# Southern Water Aylesford Sludge Treatment Work Permit Application – Response to Environment Agency

<b>Environment Agency reference:</b>	<b>EPR/DP3998HH/V007</b> (file reference Application Variation RFI and payment letter 24052024.pdf)	<b>Date:</b>	<b>14 June 2024</b>
Prepared by:	Shannon Stone	Checked by:	Anita Manns
Approved by:	Anita Manns	Document reference:	790101_NDM Response_AYL June 2024

Figure 1: Wastewater Treatment Works schematic

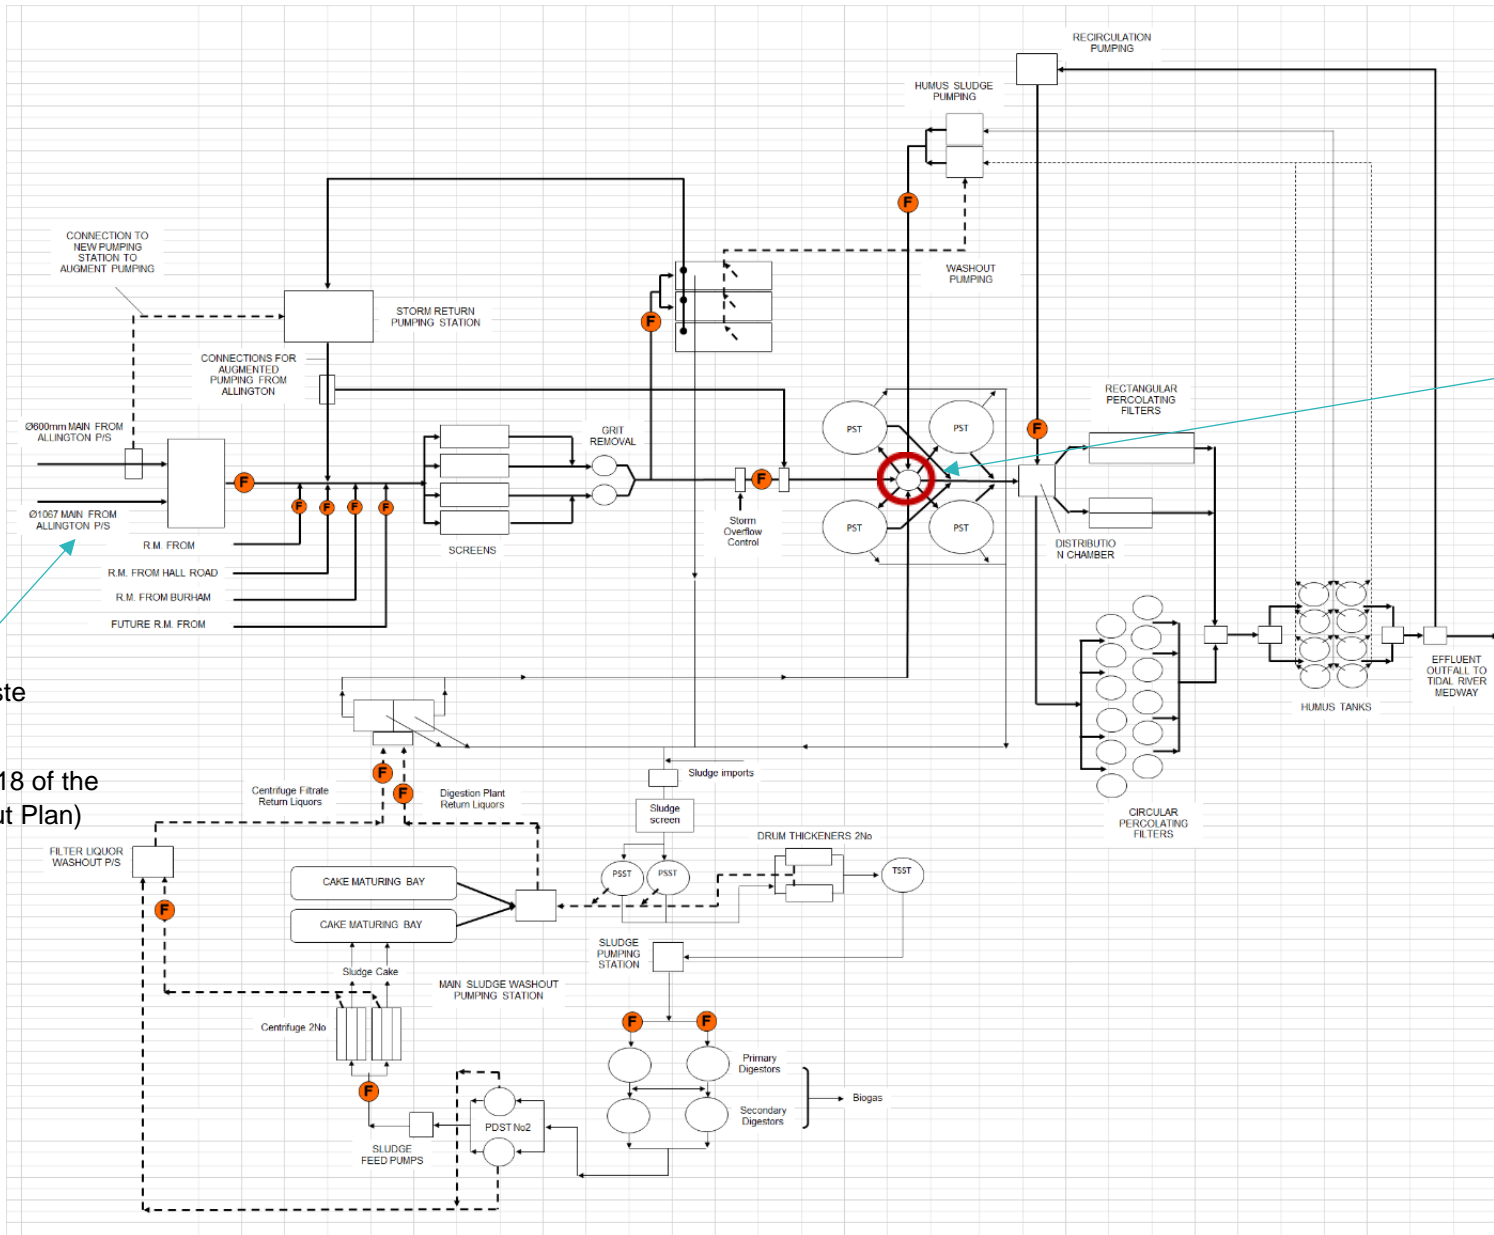
Application EPR/DP399 8HH/V006	13	<p>a) Clearly explain the purpose of the balancing tank and processes prior to discharge of waste to the head of works</p> <p>b) Confirm if you are applying for to vary your existing waste activity to an installation.</p>	<p>Tankered trade waste is accepted to site to join incoming flow from Allington WPS, then via a channel adjacent to works inlet. Tankered trade waste therefore passes through the screens and into WwTW process.</p> <p>The term 'balancing tank' is a generic term for the tank at the Site that manages flows into the four PSTs. There is no draw off that takes different constituents (ie sludge, and liquors) away from the tank. The only draw-offs are for the contents of the 'balancing tanks' to return to the PSTs for top up.</p> <p>The use of the balancing tank, and the passing of wastes through other assets</p>

Topic of relevancy	Question no.	Question	Response
			<p>(screens and grit removal) before entering the head of the works does not change the characteristic of the received waste and does not constitute a treatment process. The screens and grit screens are for the purpose of removing detritus to benefit 'downstream' assets, such as the PSTs. Please see Figure 1 of this document for schematic to demonstrate the location and waste transfer through the balancing tank.</p> <p>The variation application is to:</p> <ol style="list-style-type: none"> <li>1. Modernise the conditions of the existing physical treatment activity (A16) as authorised under the permit reference EPR/DP3998HH, and to increase the annual throughput of this activity to <b>59,000 tonnes per annum</b> (V006 states 56,000 tonnes per annum), and;</li> <li>2. Add the Schedule Activity for the anaerobic digestion of sewage sludge.</li> </ol> <p>Southern Water confirm the intention is not for the current waste activity listed in EPR/DP3998HH to be converted to a Scheduled Activity. The characteristics of the received waste destined for the head of the works (ie not via anaerobic digestion) does not change. Therefore, it is understood the request to increase to <b>59,000 tonnes per annum</b> does not constitute a change to an installation activity.</p>
